SPS Integration of the RFD cryomodule

Date: 14/11/2019

Meeting minutes

Integration model

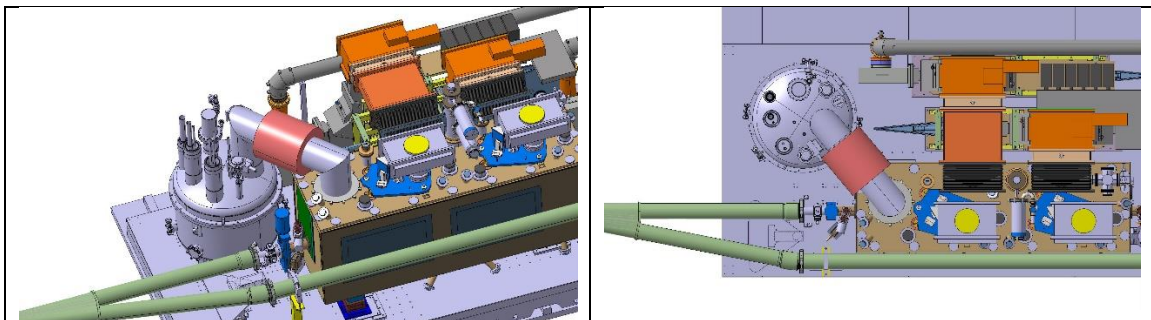
The integration ST model contains also the top plate with fixation holes, but this is not appearing – as it should. Indeed, it will not be possible to drill additional holes in this top plate and adjustment intermediate plates may not withstand the torque due to differences in vacuum or pressure pipe diameters, if not fully bolted to the top plate. It is therefore required that this plate, 10mm in thickness, is always included in the integration studies. The hole's position impacts the fixations to the table of all elements: jacks, vacuum chamber supports, Service Box feet, charge and circulator's skids.

Second beam tube

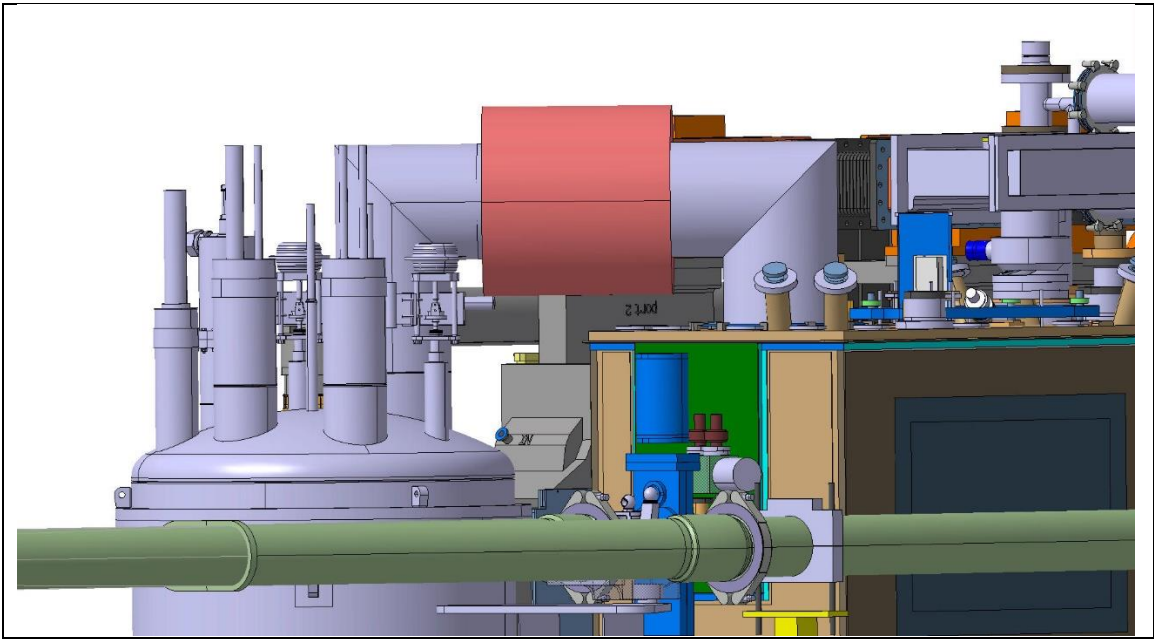
No sector valve (yellow on Scharif's presentation) will be installed in the SPS test. However, active pumping of the second beam pipe is under discussion. One minimal solution would be to pump down, then seal under static vacuum and equip the second beam pipe with a valve, gauge and burst disk + safety valve. A second solution would be to connect from outside the second beam pipe vacuum and the insulation vacuum equipment or volume.
